MFN 07-439

**Subject: Response to Portion of NRC Request for Additional Information
Letter No. 85 - Decay Heat Analysis - RAI Number 6.3-62**

Decay Heat Analysis

RAI Number 6.3-62

Figure 6.3-62-1 (DCD Tier 2, Figure 6.2-8c)

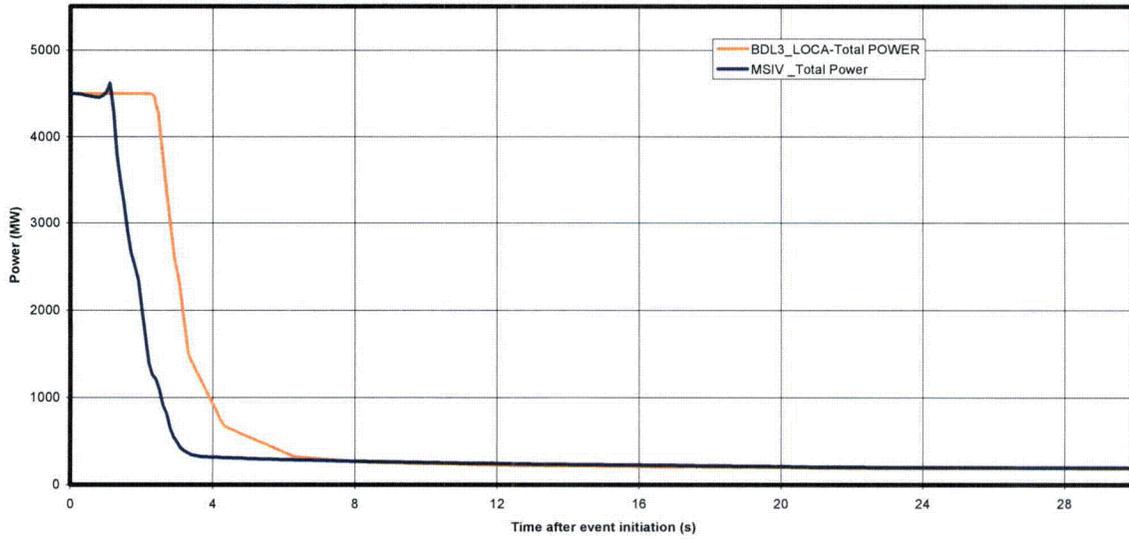
- (B) A justification of the application of the same decay heat curve to both small and large break LOCAs. Particularly, provide an analysis demonstrating that the assumptions used to calculate the fission power during rod insertion and fission power from delayed neutrons are conservative for a full spectrum of LOCAs. If a TRACG analysis is used to demonstrate the conservatism, fully describe the calculation; including the specific decay heat option used, the initiator for the SCRAM signal, the evolution of the core average void fraction, and any assumptions regarding blade insertion time or axial load.*

- (B) The total power comparison between the main steam isolation valve (MSIV) closure transient at EOC and bottom drain line (BDL) small break LOCA events demonstrates that there is no detrimental impact from the use of the calculated decay heat for the ESBWR LOCA break spectrum analyses. This conclusion is based on the higher potential of the MSIV closure transient at EOC event to insert positive reactivity (higher total power) compared to the BDL small break LOCA event. The potential for positive reactivity insertion is due to an expected lower void fraction from the MSIV closure transient at EOC pressurizing event. Therefore, if the total power from the BDL small break LOCA bounds the total power from the MSIV closure transient at EOC, the calculated decay heat used in the ESBWR LOCA spectrum is considered to be adequate and conservative. This is true because the main steam line (MSL) large break LOCA has an immediate negative void feedback greater than that of the BDL small break LOCA event, and the negative void feedback of the BDL small break LOCA is greater than that of the MSIV closure transient at EOC event.

Figure 6.3-62-1 (DCD Figure 6.2-8c) "Comparison of MSIV Closure Transient and BDL Break LOCA Decay Heat" shows that during both the early high energy gradient and later stages of these events, the decay heat power from the BDL small break LOCA (DCD Tier 2, Revision 3, Subsection 6.2.1.1.3.3) is higher than the one from the MSIV closure transient at EOC (DCD Tier 2, Revision 3, Subsection 15.2.2.7), except for a small time where the MSIV closure transient at EOC decay heat is (about 3%) above the nominal power for about 0.2 seconds (between 1 to 1.2 seconds into the event). Even though the decay heat from the MSIV closure transient at EOC event is slightly higher for a very short time, the contribution from this small peak to total power is shown to be negligible when compared to the time-integrated power for both events (as seen in Figure 6.3-62-2 and Figure 6.3-62-3). Furthermore, the pressure increase due to the MSIV closure transient at EOC and its positive reactivity insertion impact is neutralized by the negative reactivity

from the control rod insertion. The impact on power from the negative void feedback during a BDL small break LOCA is greater than the one caused by the MSIV closure transient at EOC, because the transient event involves more limiting conditions that promote a smaller negative void feedback or none at all. Therefore, based on the behavior shown in the above comparison, it is demonstrated that the same decay heat values are applicable to the LOCA spectrum events identified in DCD Tier 2, Revision 3.

DCD Tier 2, Figure 6.2-8c will be revised consistent with Figure 6.3-62-1 in this response. DCD Tier 2, Subsection 6.2.1.1.3 will be revised to add the text shown in the attached markup.
